**BELLEFONTE COMBINED LICENSE APPLICATION – RESPONSE TO REQUEST FOR
ADDITIONAL INFORMATION – SHORT TERM ATMOSPHERIC DISPERSION
ESTIMATES FOR ACCIDENT RELEASES**

Subject: Short Term Atmospheric Dispersion Estimates for Accident Releases in the Final Safety
Analysis Report

NRC RAI NUMBER: 02.03.04-05

Figure 02.03.04-05A

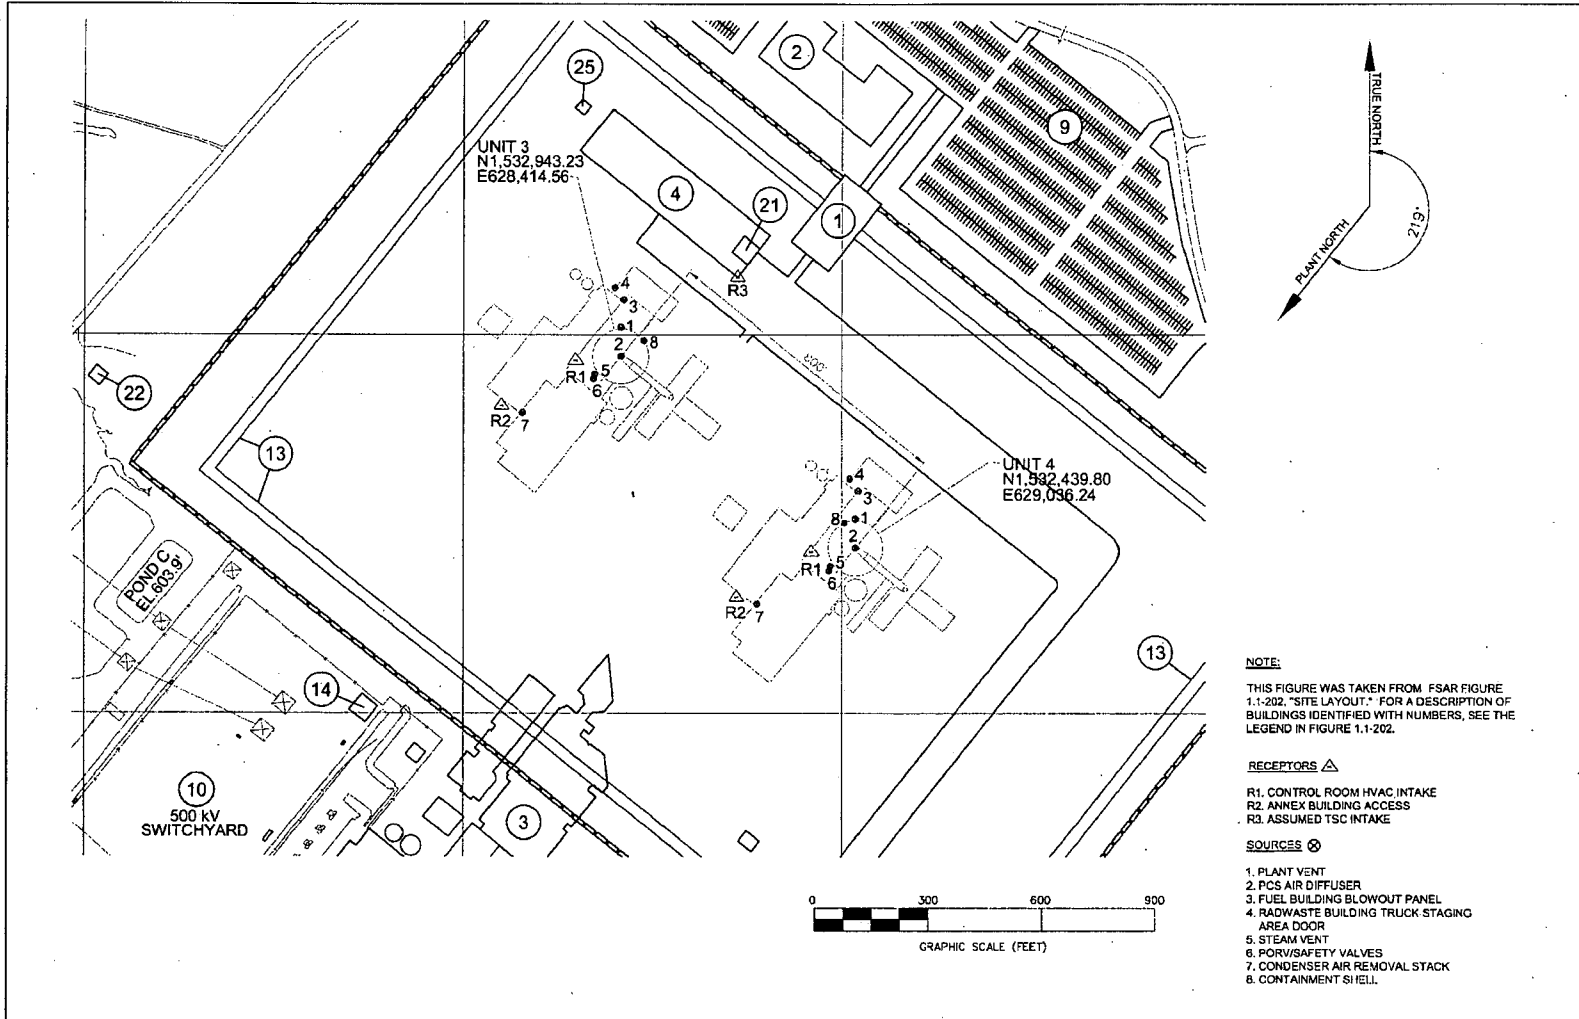
The applicant has taken a departure in FSAR Chapter 18, Human Factors Engineering, in that the Bellefonte TSC is not located in the control building as identified in the AP1000 DCD (Departure No. BNL DEP 18.8-1). Provide a description of the methodology, inputs, assumptions, and calculated atmospheric dispersion factors (χ/Q values) for releases from the Plant Vent, PCS Air Diffuser, Fuel Building Blowout Panel, Fuel Building Rail Bay Door, Steam Vent, PORV/Safety Valves, Condenser Air Removal Stack, and Containment Shell to the Technical Support Center (TSC). Information provided should be analogous to that provided for releases to the control room and include drawings to show relevant information graphically. Consider providing the computer input files as part of the response.

The TSC is located in the east end of the BLN maintenance building as shown in the Site Layout, FSAR Figure 1.1-202. Exact locations of the receptors of interest, the TSC HVAC intake and facility entrance, are not yet final; therefore, they are conservatively assumed to be located on the wall of the new maintenance building closest to Unit 3 at an elevation of 1.5 m (see Figure 02.03.04-05A below).

The AP1000 release locations are given on DCD Figure 15A-1 and Table 15A-7. When these locations are transposed onto the BLN Site Layout as shown in Figure 02.03.04-05A, it can be seen that the general

direction from the assumed TSC receptors to the majority of the release locations is very similar. The release locations that are closest to the TSC are the containment shell, the plant vent, the fuel building blowout panel, and the radwaste building truck staging area door. According to the AP1000 DCD Table 15A-6, the fuel building blowout panel and the radwaste building truck staging area door are release locations associated with spent fuel pool boiling and the fuel handling accident (FHA) occurring outside containment, respectively. Spent fuel pool boiling occurs as a result of loss of spent fuel pool cooling. The 30-day contribution of pool boiling to the dose at the low population zone boundary is less than 0.01 rem TEDE (see DCD Subsection 15.6.5.3). The duration of the FHA is two hours. In addition, the offsite doses are 25 percent or less than the dose guideline of 25 rem TEDE identified in 10 CFR 50.34 (see DCD Subsection 15.7.4.5). The limiting AP1000 offsite radiological consequences are associated with a LOCA with core melt scenario (see DCD Table 15.6.5-3). Therefore, since the distance and direction to the containment shell and plant vent are similar and the release height of the containment shell is lower, the containment shell is the most conservative LOCA release location to consider in the evaluation of TSC atmospheric dispersion values. Therefore, a LOCA release from the containment shell is conservatively assumed.

The containment shell is a diffuse area source. The height and width of the area source are taken as the maximum vertical and horizontal dimensions of the above grade shield building cross-sectional area perpendicular to the line of sight from the building center to the TSC receptor location. The area of the containment obscured by the radwaste and auxiliary building was determined and subtracted from the total projected area of the containment to determine a representative area of the diffuse source, i.e., 36.6 m (120.1 ft) high by 44.2 m (145 ft) wide. The release height is set at the vertical center of the projected plane. The source-to-receptor distance is measured from the shield building to the TSC intake. Based on this approach, the vertical and horizontal diffusion coefficients are determined to be 6.1 m (20.0 ft) and 7.4 m (24.2 ft), respectively. The release height is at elevation 64.7 m (212.3 ft) or 34.2 m (112.3 ft) above grade. The horizontal distance from the projected plane of the Unit 3 containment to the TSC HVAC inlet is 91 m and the horizontal distance from the projected plane of the Unit 4 containment to the TSC HVAC inlet is 224 m as given in Table 02.03.04-05A below.
